LaSalle County Station, Units 1 and 2
Facility Operating License Nos. NPF-11 and NPF-18
NRC Docket Nos. 50-373 and 50-374

Subject: Response to Request for Additional Information License
Amendment Request for Power Uprate Operation

Attachment
Response to Request for Additional Information

The following questions refer to Attachment E of your submittal dated July 14, 1999, GE Report NEDC-32701P, "Power Uprate Safety Analysis Report for LaSalle County Station, Units 1 and 2."

Figure 4-1: Short-Term Drywell and Wetwell Pressure Response to DBA-LOCA For Power Uprate Conditions (102% of 105% Rated Thermal Power)

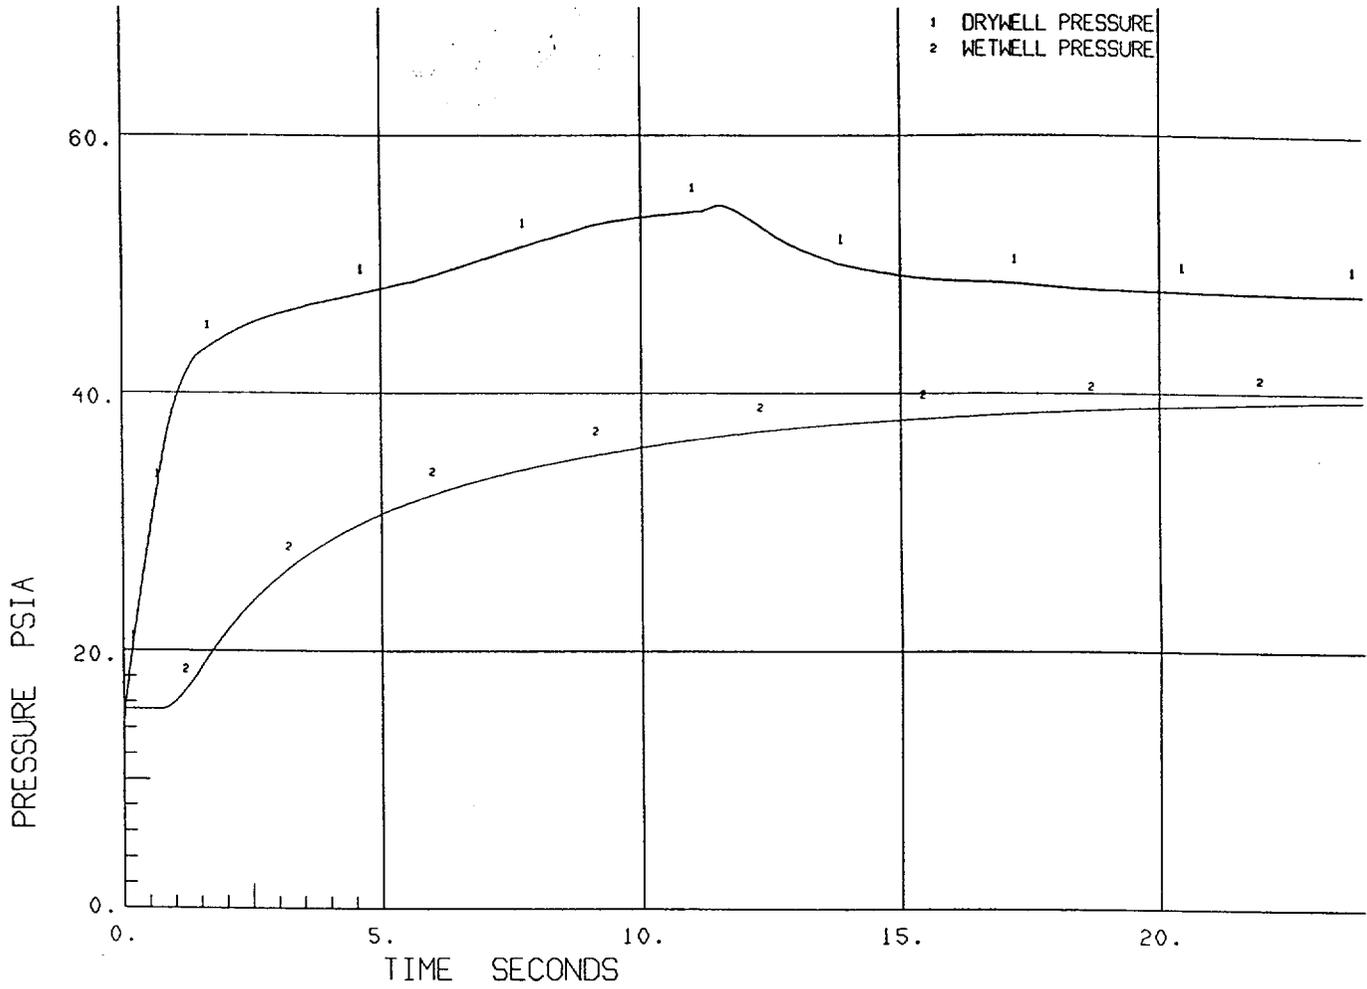
Please provide the Containment Maximum Pressure and Temperature analyses curves at uprated power.

Please refer to the attached Figures 4-1 through 4-6, for the power uprate (and re-analyzed current rated power), drywell pressures and temperatures responses for the DBA-LOCA (a double-ended break of a recirculation suction line).
